Groundwater Transfer Review Summary Form

Transfer/PA # T- 14666

Ground Water Review Form:

Application: T-14666

Well Location Map

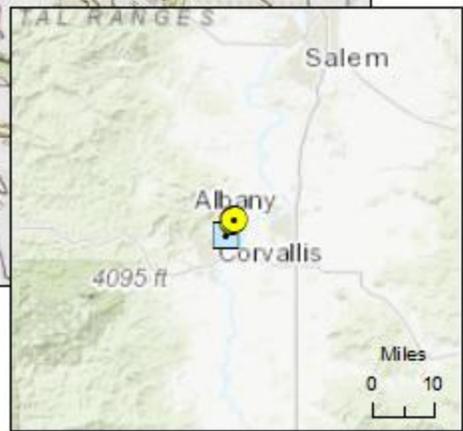
1. Basic description of the changes proposed in this transfer: Applicant proposes to change the POU and POA for 46.39 acres of Claim GR-3558, which claims 0.4902 cfs from one well ("Pump Well 1" / BENT 2659) for Irrigation of 93.29 acres. The proposed change would transfer 0.2438 cfs of the total rate (and corresponding acreage) to proposed POA "Well 1" (BENT 55321) and "Well 2" (BENT 55224). NOTE: The proposed To-POA wells are also proposed APOA wells in T-14663. This transfer (T-14666) will be evaluated assuming the proposed To-POA wells will pump at the combined rates proposed in T-14663 and T-14666. This is also a long-distance transfer, with the claimed From-POA being ~2 miles from the nearest proposed To-POA, "Well 1" (BENT 55321).

Yes No Comments: The proposed To-POA are substantially closer to neighboring wells BENT 55423 (authorized POA on Permit G-17980; 146.14 acres, 1.83 cfs) and BENT 2544 (authorized POA on Certificate 33903; 230.3 acres, 0.9 cfs). Proposed To-POA "Well 1" (BENT 55321) is ~1,090 ft east of neighboring well BENT 55423 (Permit G-17890). Proposed To-POA "Well 2" (BENT 55224) is ~1,390 ft west of neighboring well BENT 2544 (Certificate 33903). The claimed From-POA, by contrast, is ~2 miles to the southwest of all these wells. The closer proximity will very likely result in an increase in interference with these wells and their associated groundwater rights.

Yes No Comments: The proposed To-POA would be closer to a downstream, perennial reach of Frazier Creek which is hydraulically connected to the alluvial aquifer.

Theis (1935) Drawdown and Recovery at **BENT 55423** from pumping at To-POA **BENT 55321**

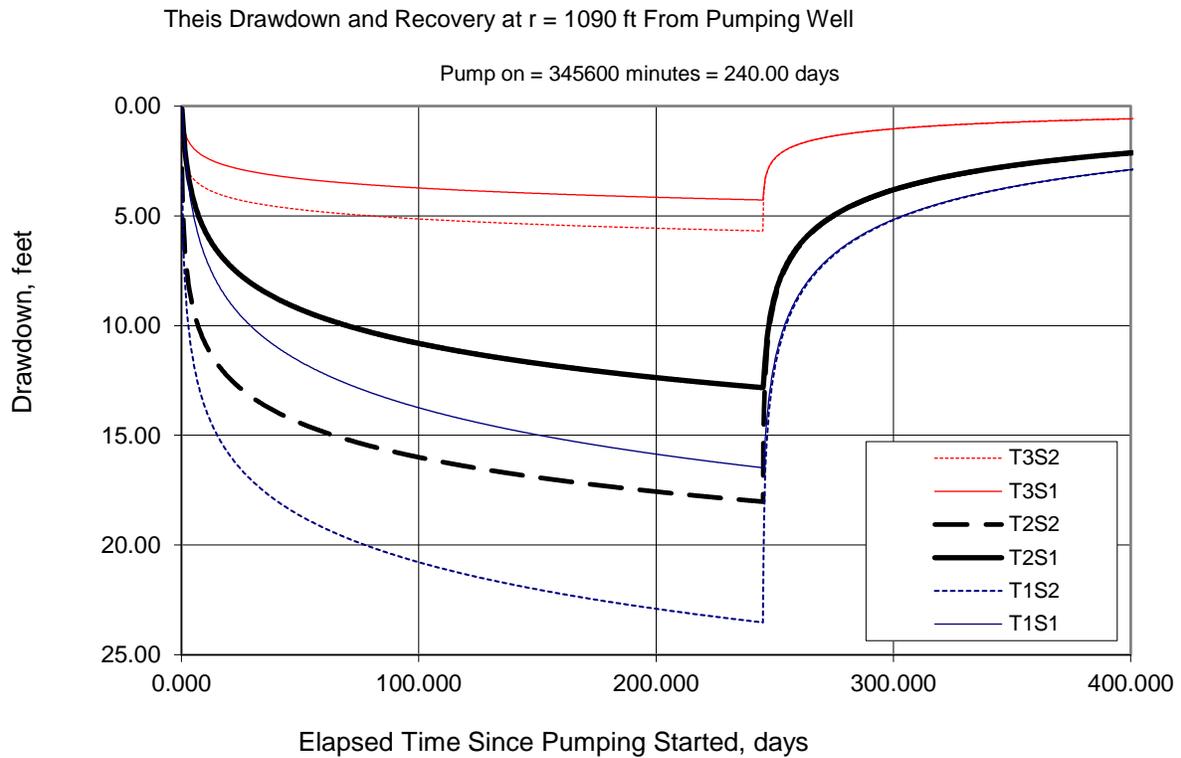
Radial distance, r = 1,090 ft [approximate distance from To-POA, BENT 55321 to BENT 55423]

Pumping time, $t_{pump} = 245$ days [irrigation season]

Pumping rate, Q = 0.6238 cfs [max rate combined rate under T-14663 and T-14666]

Transmissivity: T1=1,400 ft²/day | T2=1,900 ft²/day | T3=7,000 ft²/day [pumping test reports]

Storativity: S1 = 0.003; S2 = 0.0003 [Conlon et al., 2005]

SWL	5.10	ft bls	Permit Condition Measurement, 3/20/2025
Well Bottom	80	ft bls	BENT 55423 (fully penetrating per Gannett and Caldwell, 1998)
Available Water Column	75	ft	Well bottom-SWL (approximate)
Pump Height Above Bottom	5	ft	Estimate
NPSHa	5	ft	Estimate
Drawdown	23	ft	Estimated from pumping test for BENT 55423
Minimum Water Column	33	ft	Estimated Drawdown + NPSHa + Pump Height
Injury	42	ft	Available Water Column-Minimum Water Column

Yes No If yes, explain: Interference with neighboring wells from pumping the proposed To-POA wells was assessed using the Theis (1935) solution for drawdown in a confined aquifer. Hydraulic parameters used for the analysis were derived from regional data and studies (Pumping Test Reports; Conlon et al., 2005; McFarland and Morgan, 1996; Woodward et al., 1998). Results of the analysis indicate that the proposed change is unlikely to result in injury of neighboring wells.

Theis (1935) Drawdown and Recovery at **BENT 2544** from pumping at To-POA **BENT 55224**

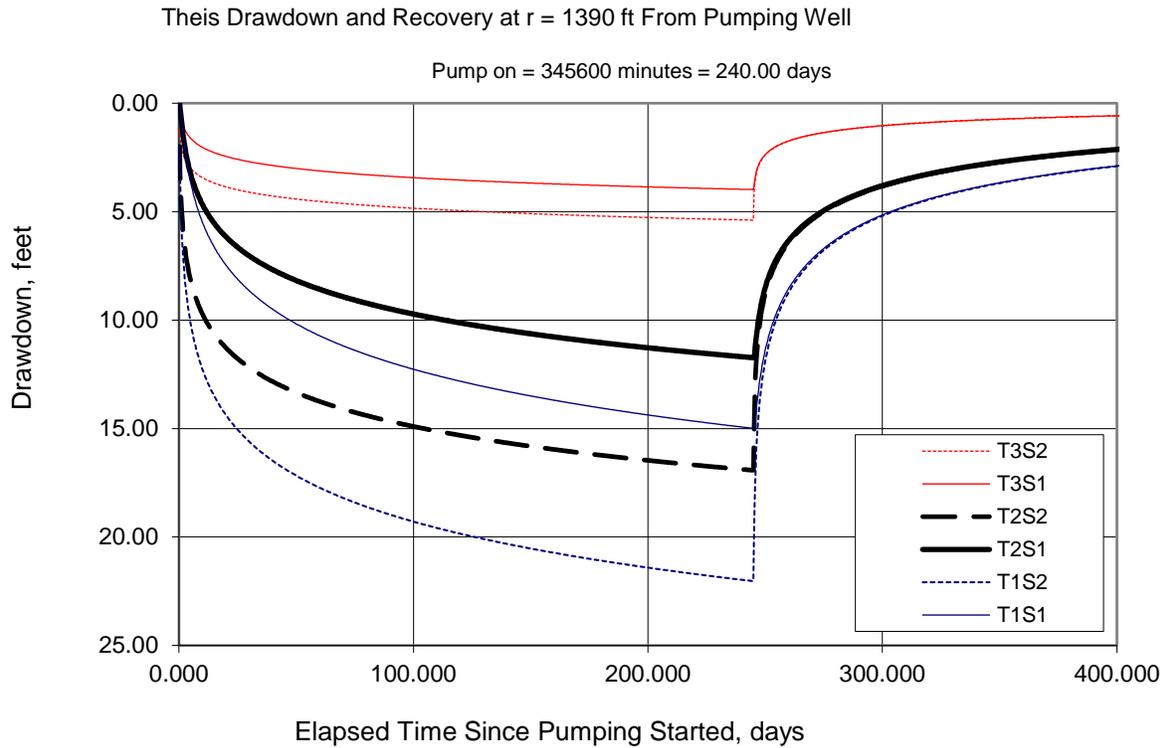
Radial distance, r = 1,090 ft [approximate distance from To-POA, BENT 55321 to BENT 55423]

Pumping time, $t_{pump} = 245$ days [irrigation season]

Pumping rate, Q = 0.6238 cfs [max rate combined rate under T-14663 and T-14666]

Transmissivity: T1=1,400 ft²/day | T2=1,900 ft²/day | T3=7,000 ft²/day [pumping test reports]

Storativity: S1 = 0.003; S2 = 0.0003 [Conlon et al., 2005]

SWL	18.53	ft bls	State Obs Well Measurement, 4/16/2025
Well Bottom	103	ft bls	BENT 2544 (fully penetrating per Gannett and Caldwell, 1998)
Available Water Column	84	ft	Well bottom-SWL (approximate)
Pump Height Above Bottom	5	ft	Estimate
NPSHa	5	ft	Estimate
Drawdown	32	ft	Estimated from pumping test for BENT 55423
Minimum Water Column	42	ft	Estimated Drawdown + NPSHa + Pump Height
Injury	42	ft	Available Water Column-Minimum Water Column
